SEWER PLAN AND PROFILE
MONROE CHATEAU
BRUNSWICK AVENUE
FROM MONROE ST. TO 260' S.W.Y.

APPROVED BY: *[Signature]* NO. S-170
DIRECTOR OF PUBLIC WORKS
DATE: 4-21-59 SHEET 1 OF 3 SHEETS

SEWER PLAN AND PROFILE
MONROE CHATEAU
COLORADO AVENUE
 FROM 100 FT. W. LY. OF TO MONROE ST.

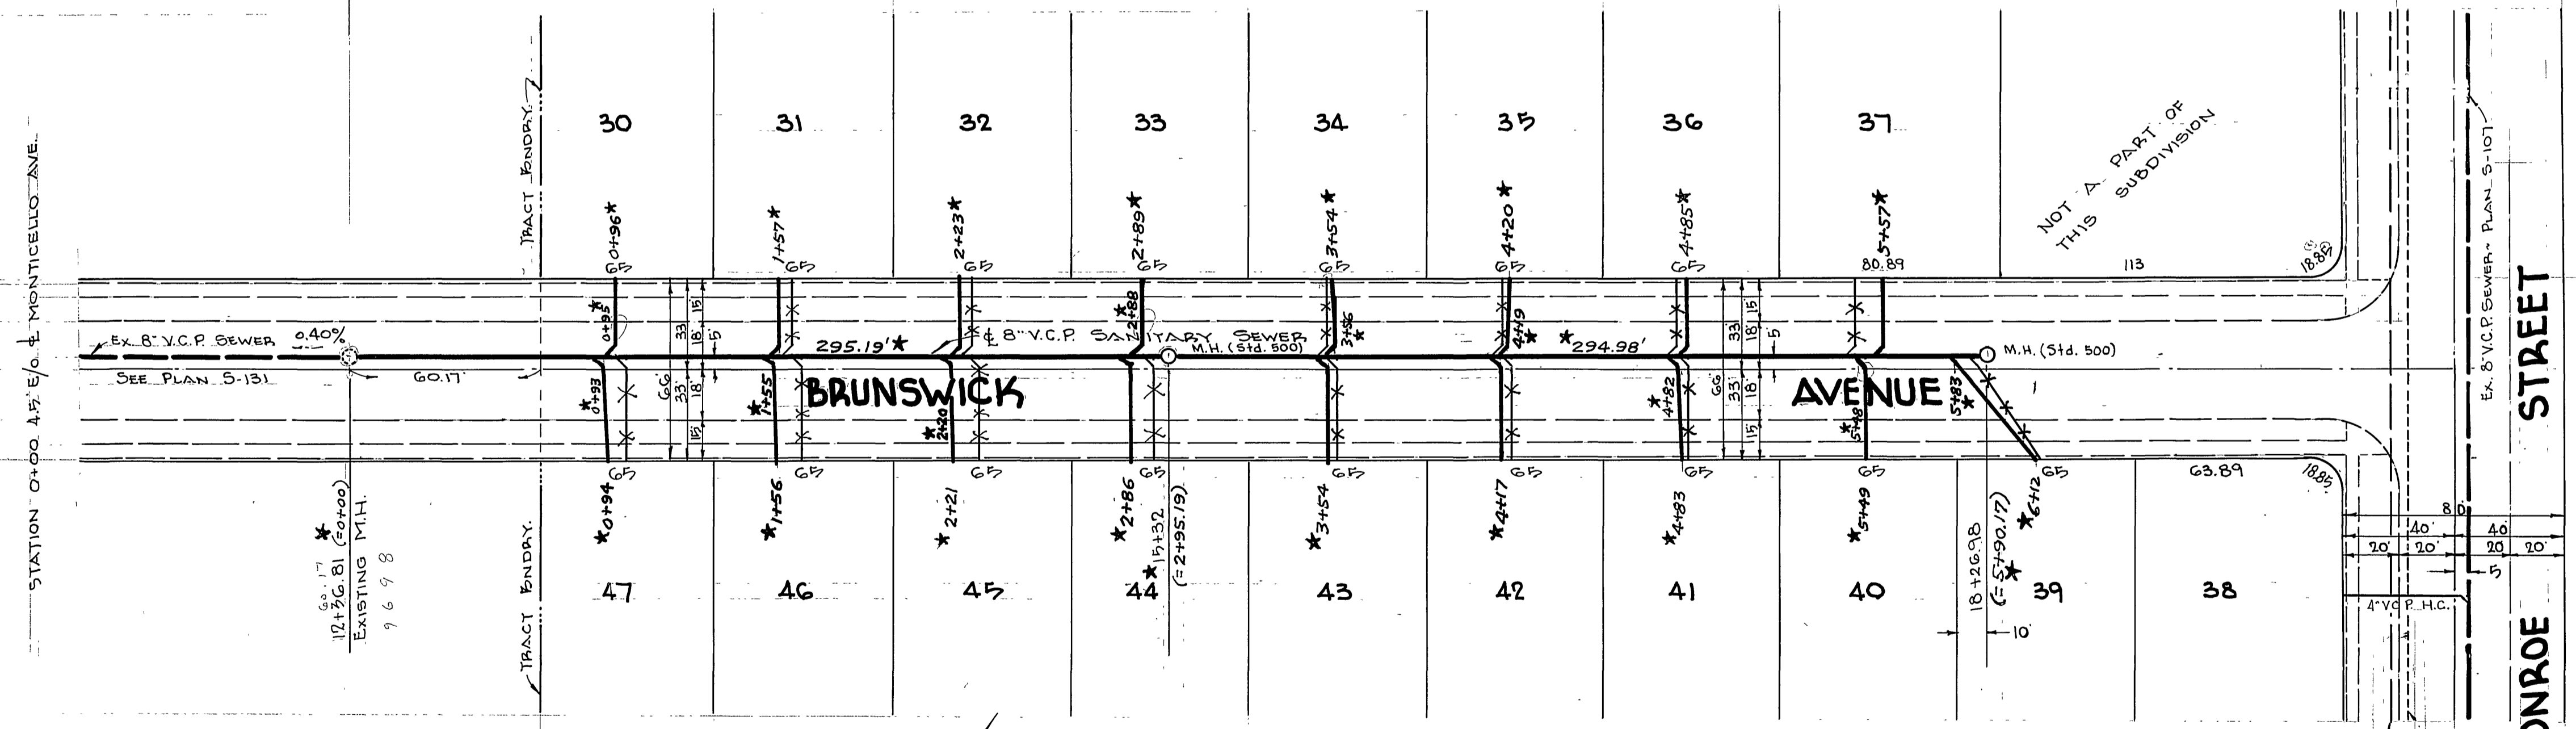
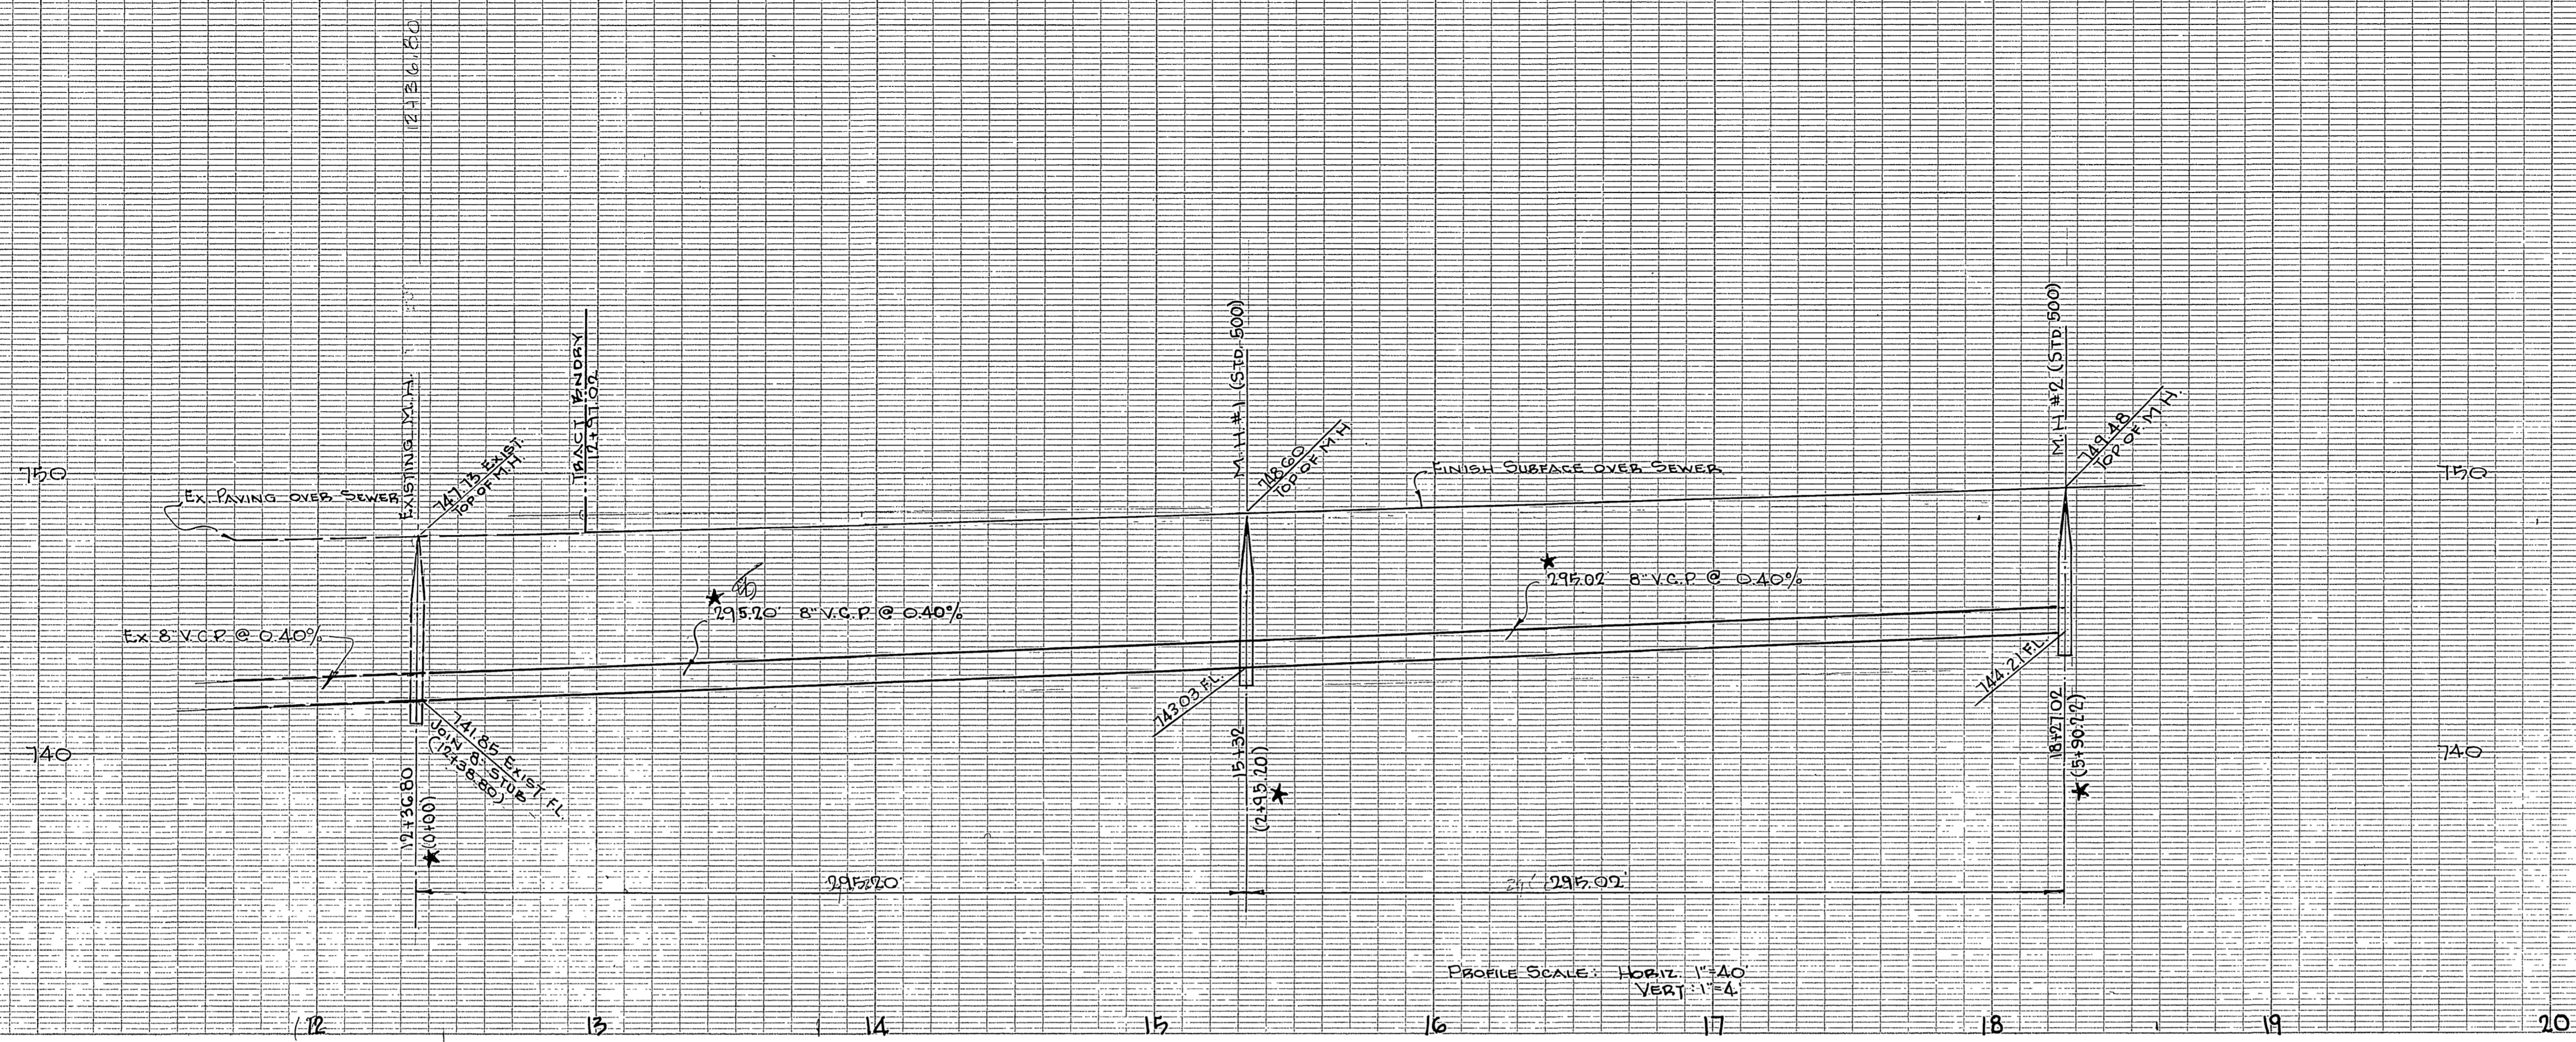
1. Eliminated 4" H.C. to NOT A PART

* "As Built" 7-16-59 H.B.H.

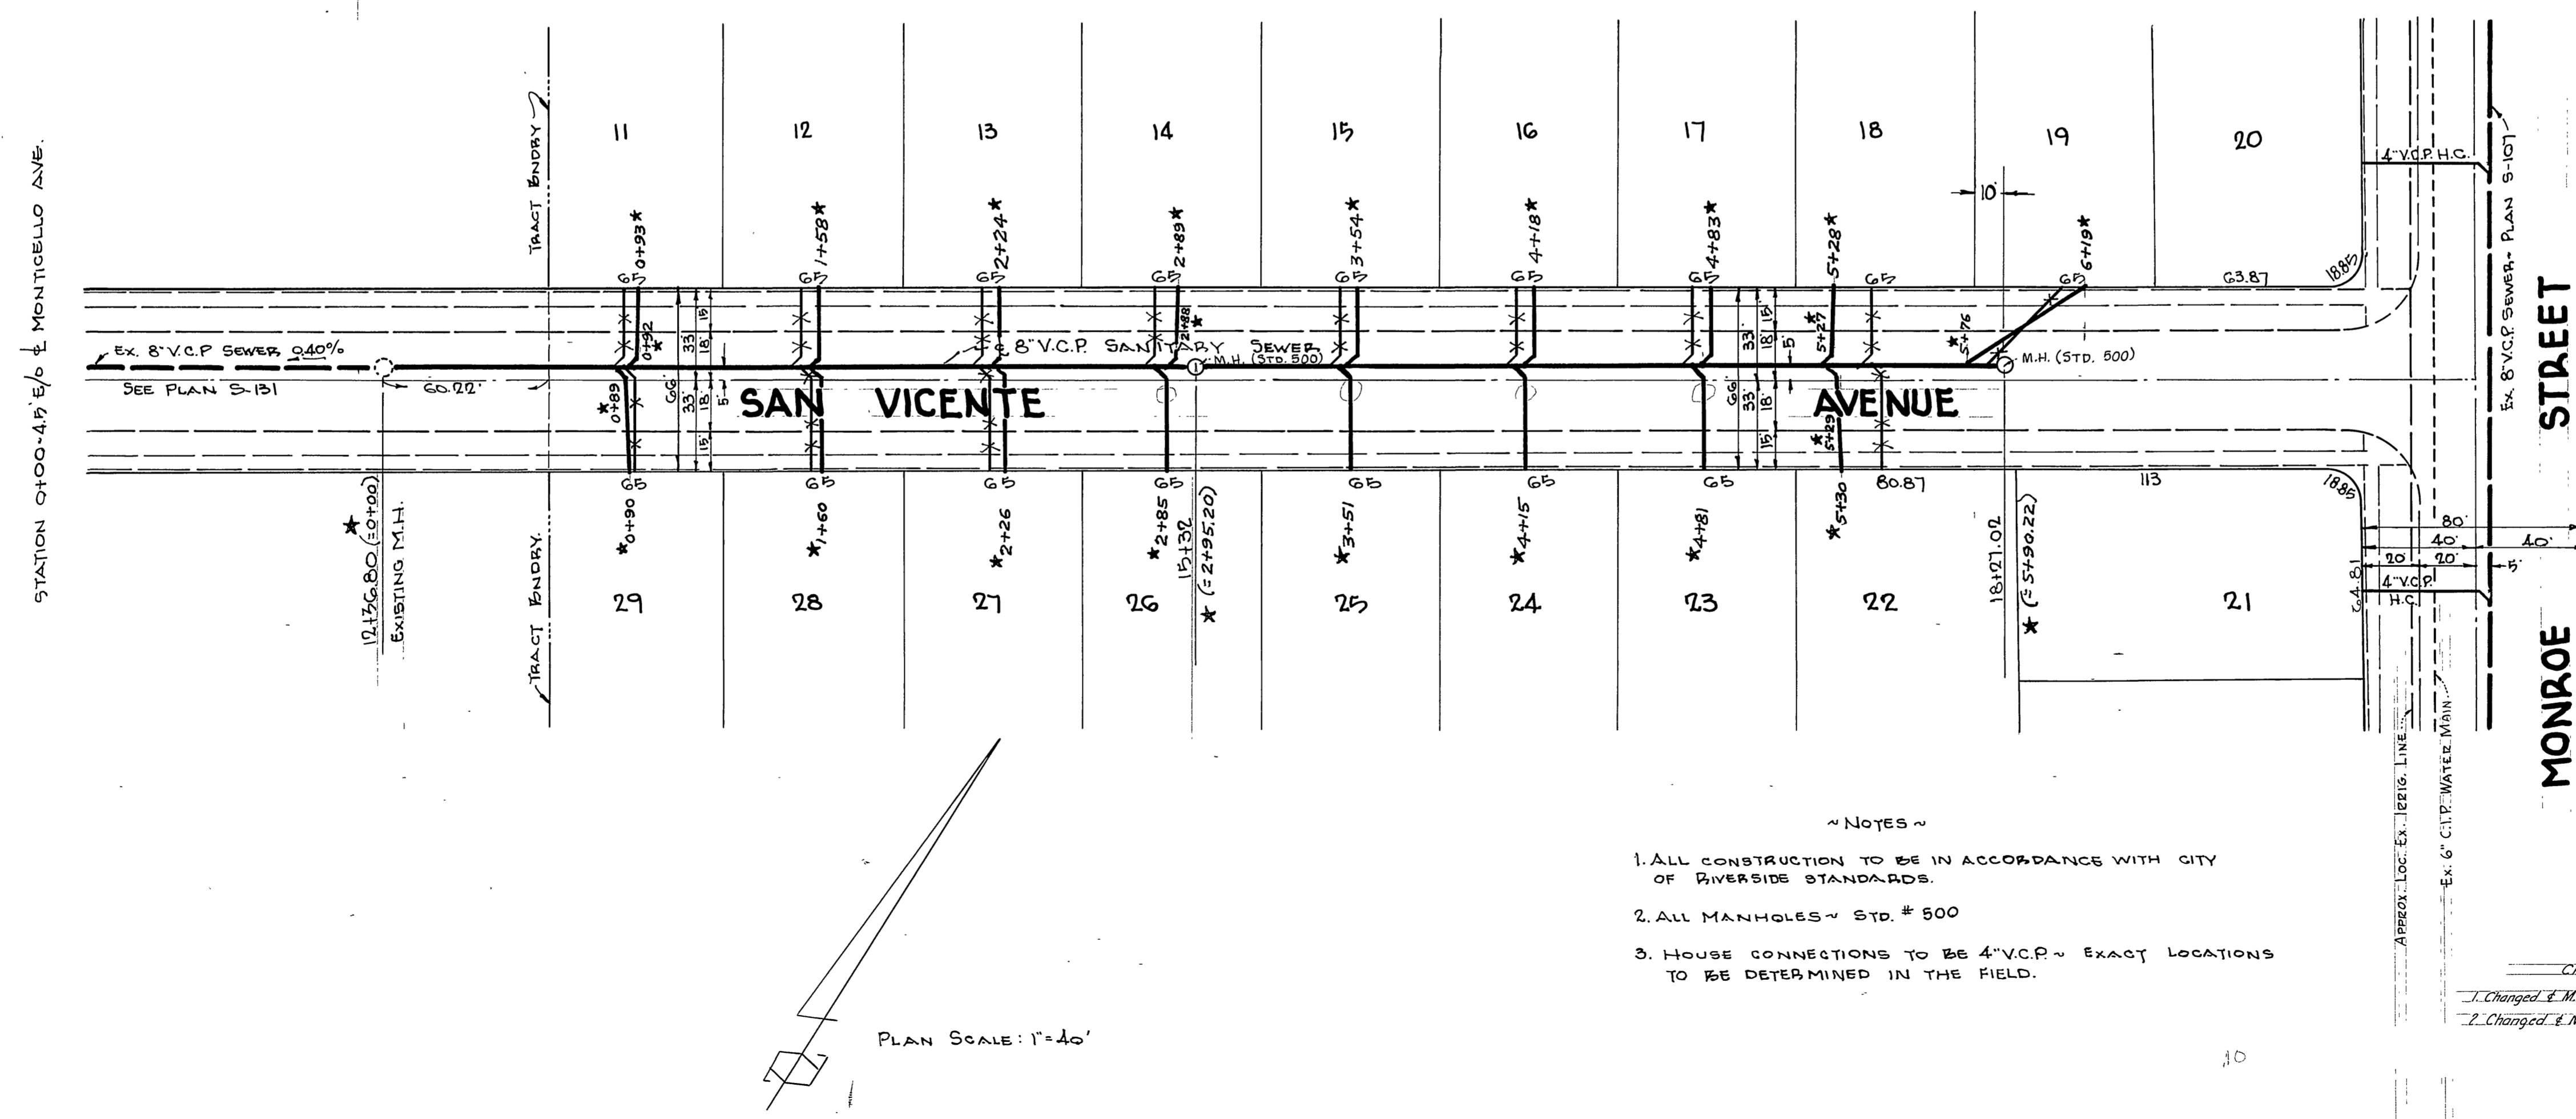
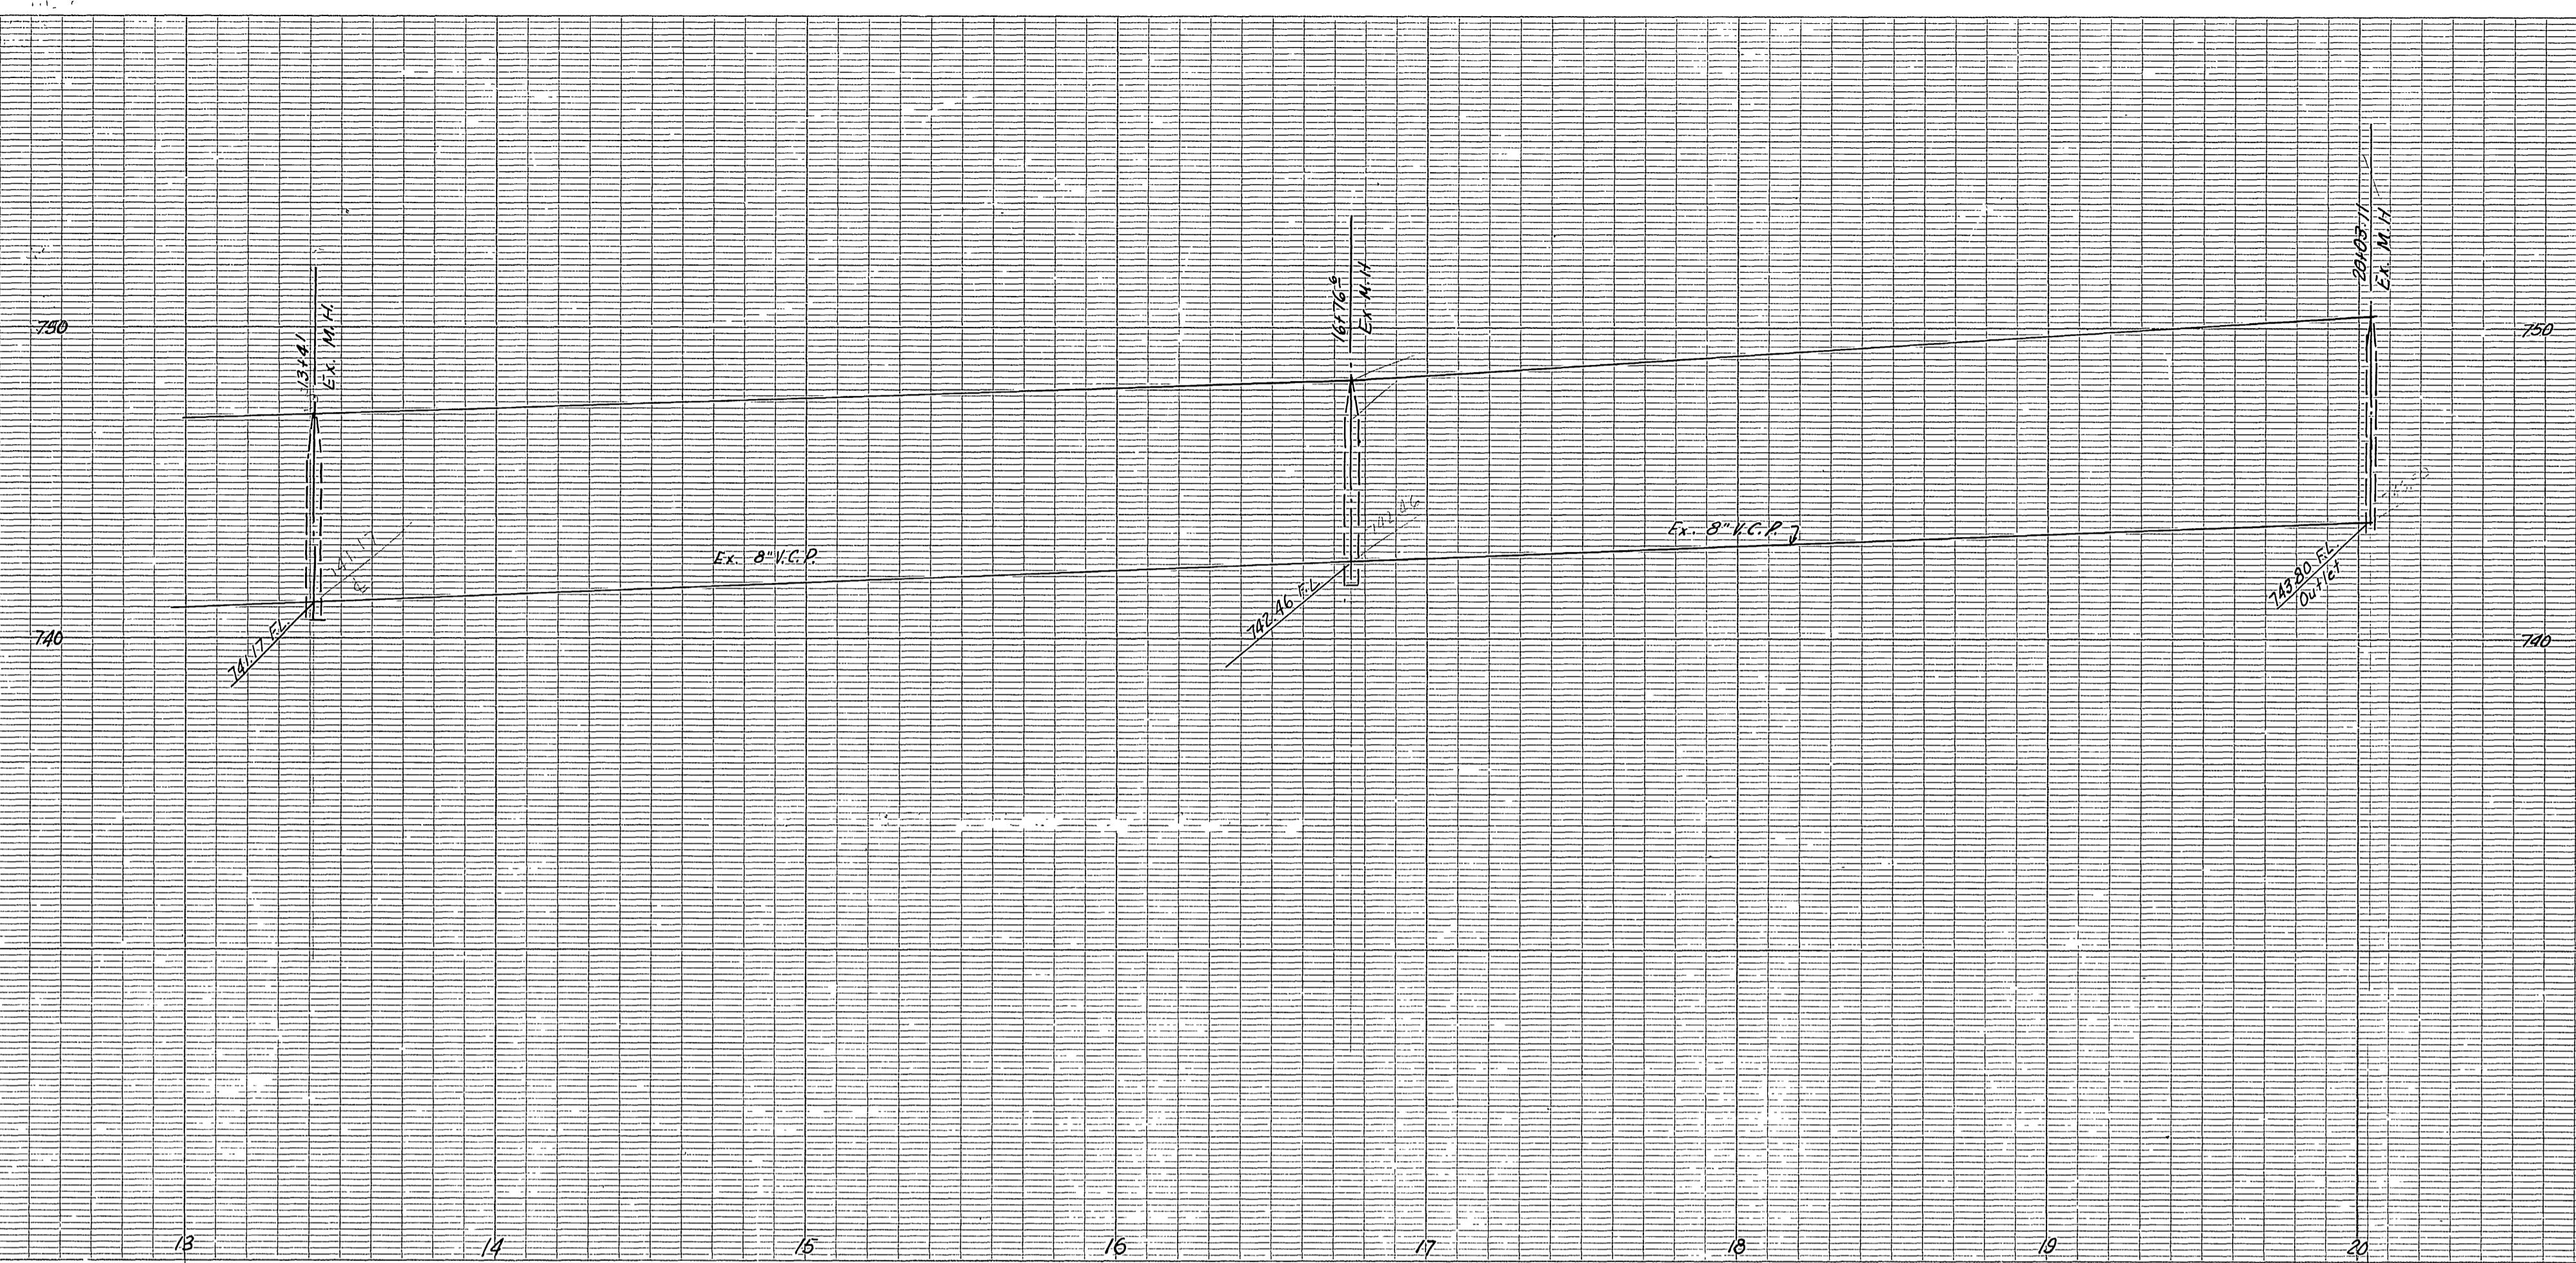
CHANGE NOTE
 1. Changed 4" M.H. Elev. M.H. No. 1
 2. Changed 4" M.H. Elev. M.H. No. 2

* = "As Built," 7-16-59, H.B. Ball
